PSL - Frequency Stabilization

80 MHz VCO Rev. B

Change Summary for Rev B boards

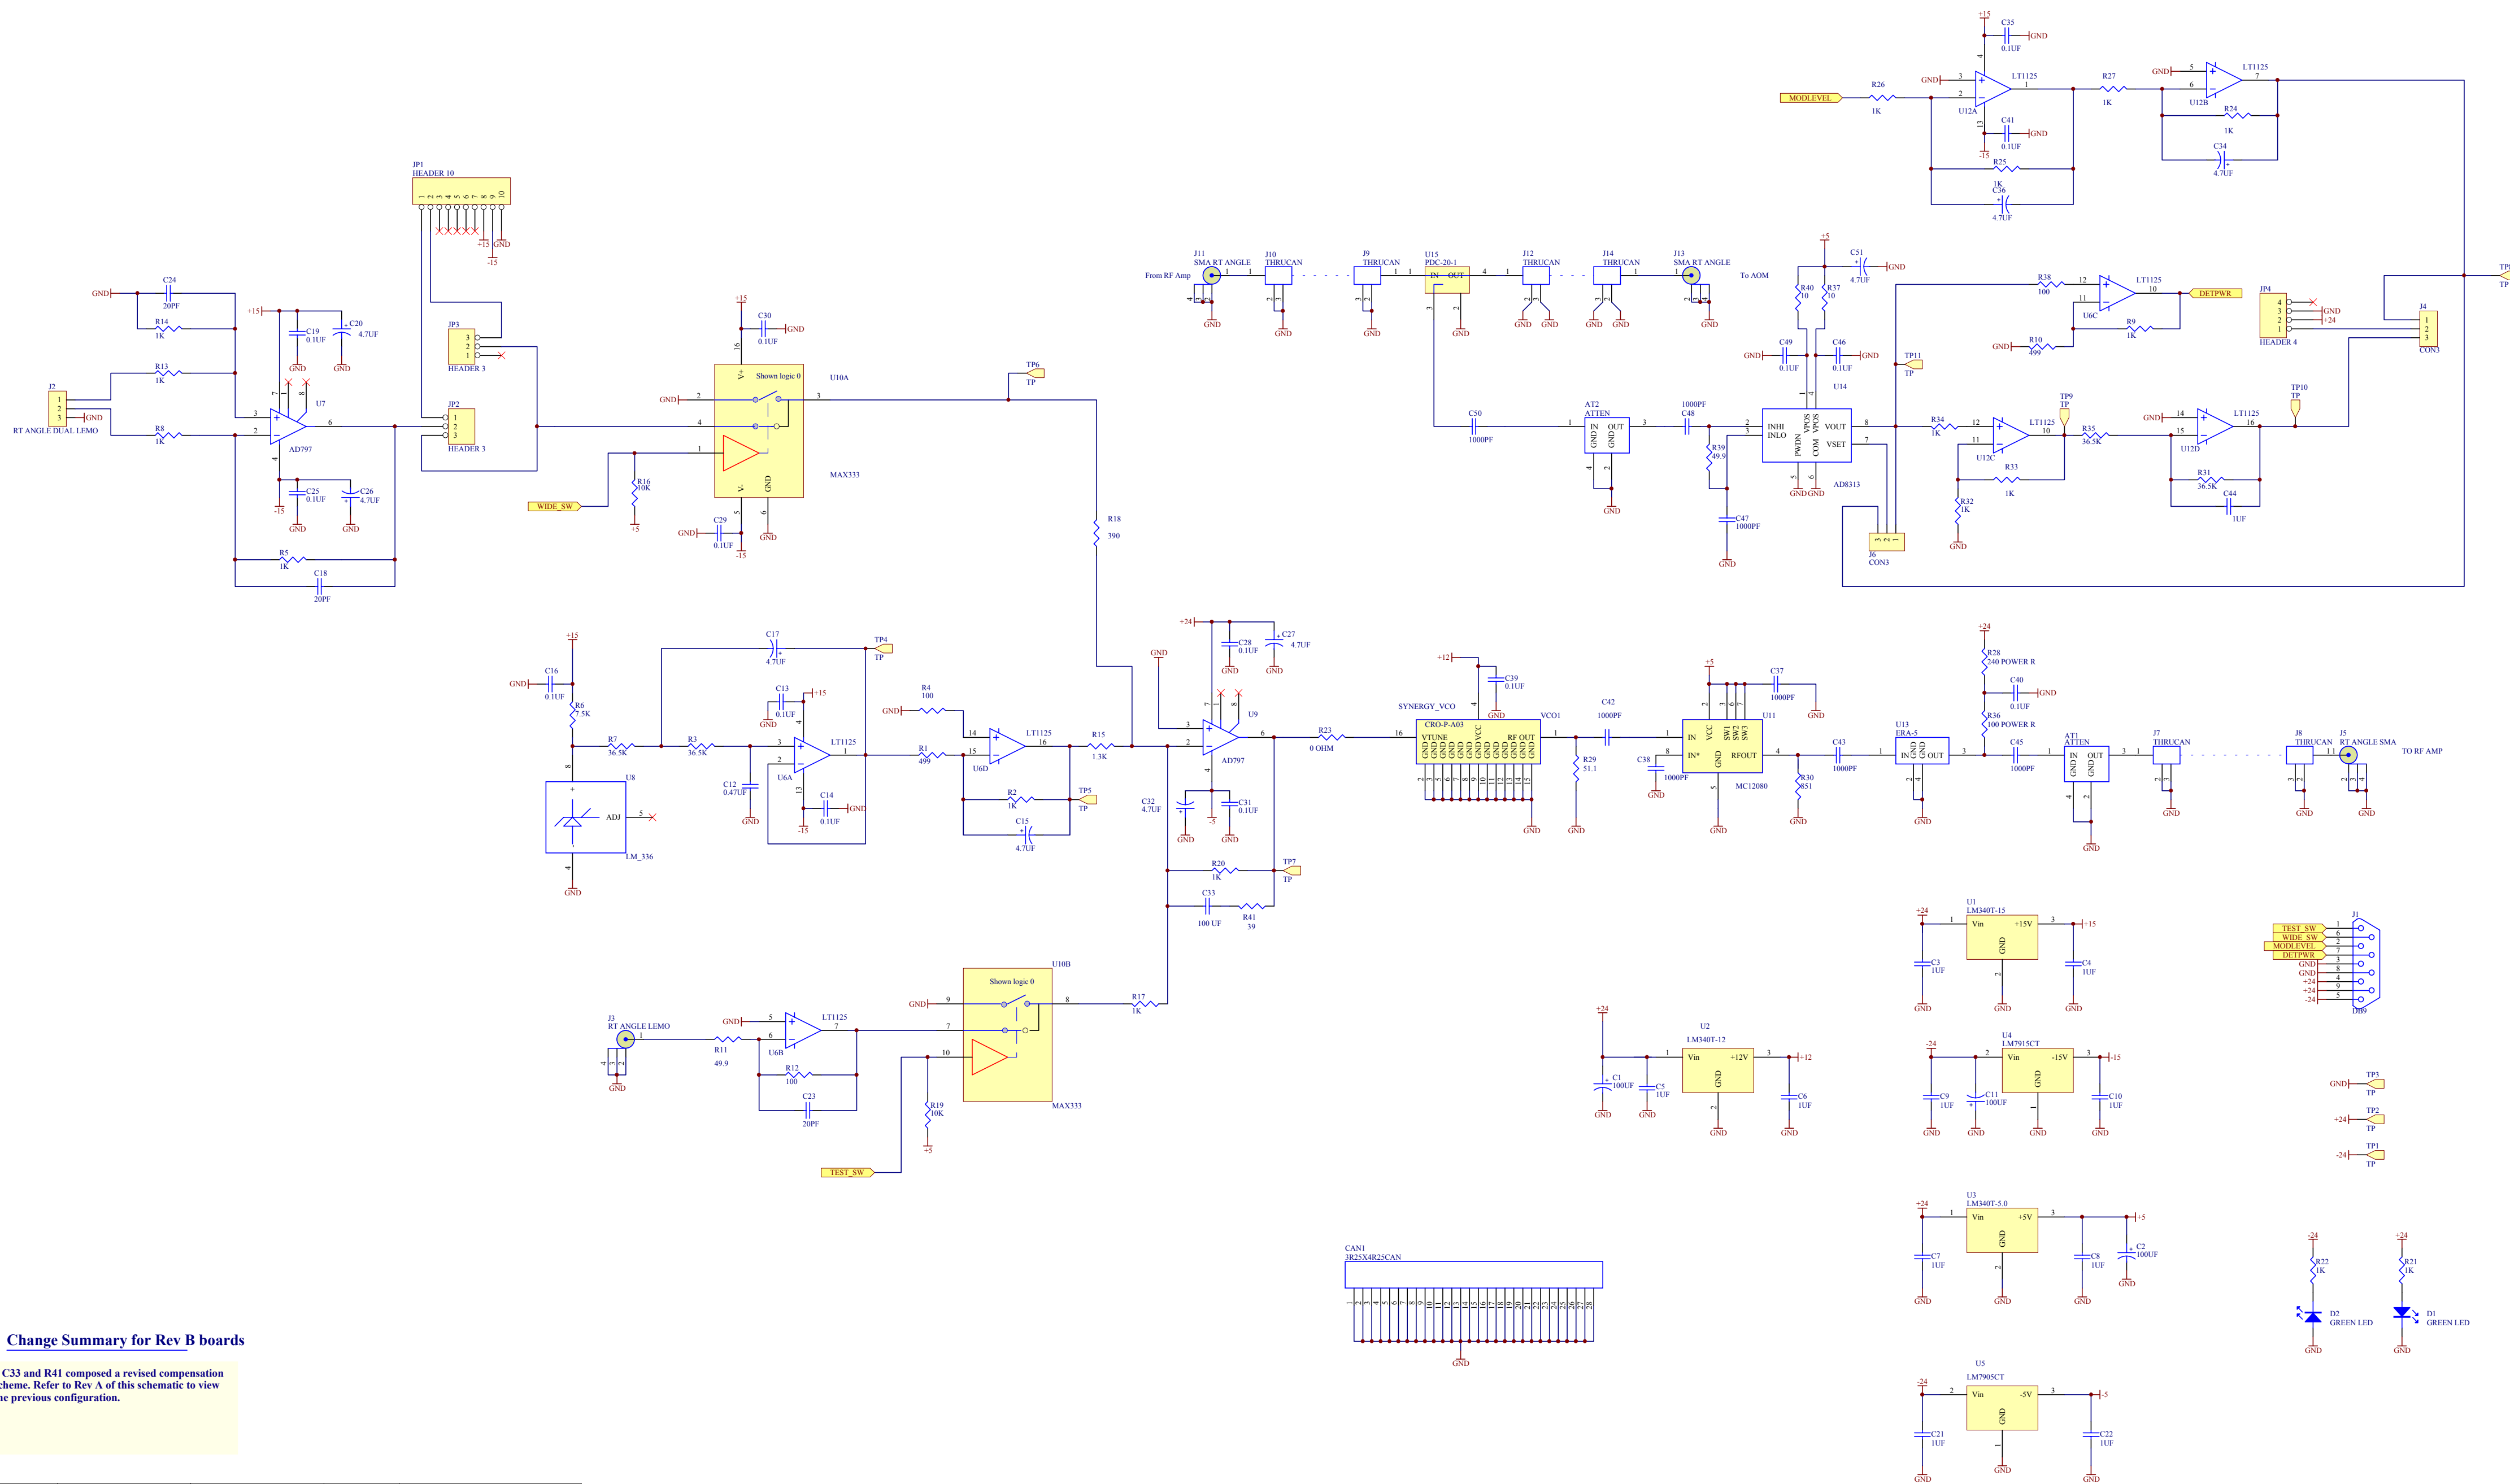
* C33 and R41 composed a revised compensation scheme. Refer to Rev A of this schematic to view the previous configuration.
